State of West Virginia  
 Department of Administration  
 Purchasing Division  
 2019 Washington Street East  
 Post Office Box 50130  
 Charleston, WV 25305-0130

NUMBER
GSD136417

Addendum Number: 2

To add a copy of the mandatory pre-bid attendee list, to answer all technical questions submitted in accordance with the provisions of the original solicitation and all issued addenda, and to extend the bid opening date. Bid opening date is extended to 06/26/2013 at 1:30 PM EST.

NEW STATE OFFICE BUILDING -  
FAIRMONT  
TYPICAL CMU PARTITION TO METAL  
DECK DETAIL

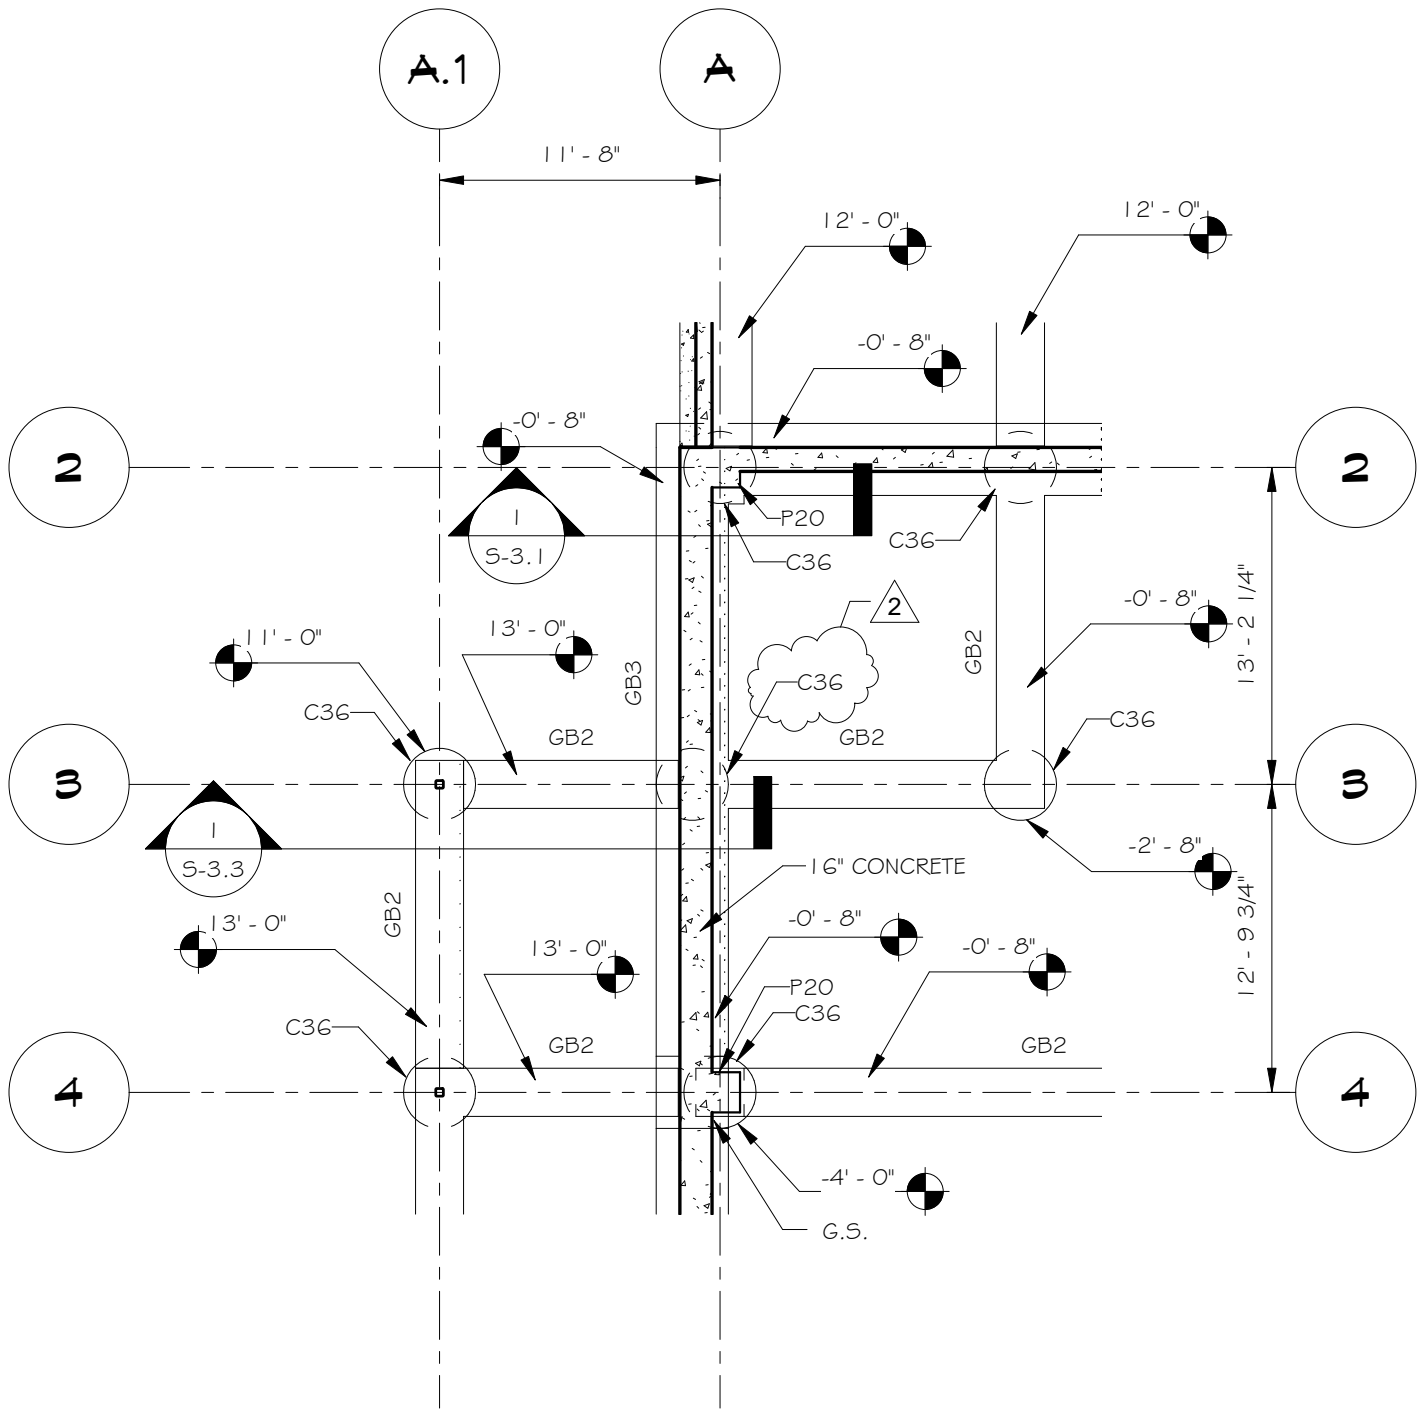
**Addendum 2 – ITEM 24, SHEET S-2.1 FIRST FLOOR PLAN**

- A. ADD Note 3 per the following: “ALL INTERIOR NON-LOAD BEARING CMU PARTITIONS (SHOWN HALFTONED) SHALL EXTEND TO THE METAL DECK AND ATTACH PER DETAIL 13/S-5.3 TYPICAL CMU PARTITION TO METAL DECK DETAIL” (this detail added per this Addendum.)

**Addendum 2 – ITEM 29, SHEET S-5.3 STEEL DETAILS**

- A. DELETE Detail 4/S5.3 TYPICAL SECTION AT ROOF and SUBSTITUTE new Detail 4/S-5.3 per Attachment N.
- B. ADD Detail 13/S5-5.3 TYPICAL CMU PARTITION TO METAL DECK DETAIL per Attachment ~~XP~~

**Question#16:** At the partition to the underside of the metal deck, please indicate if required a typical detail for this condition.

SK-5

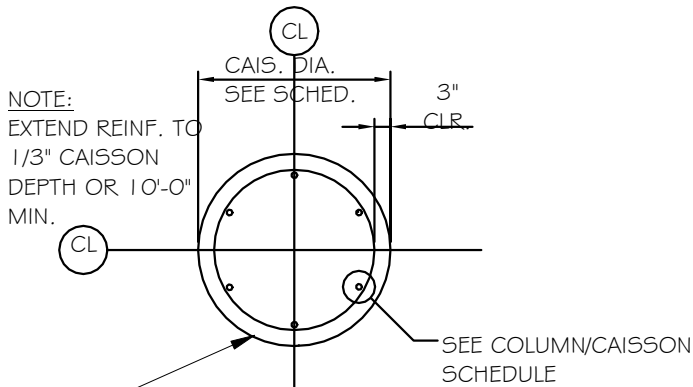
**Addendum 2 – ITEM 22, SHEET S-1.1 FOUNDATION PLAN**

- A. ADD SK-5 CAISSON DESIGNATION with clouded revision Delta 2 per **Attachment Q**.
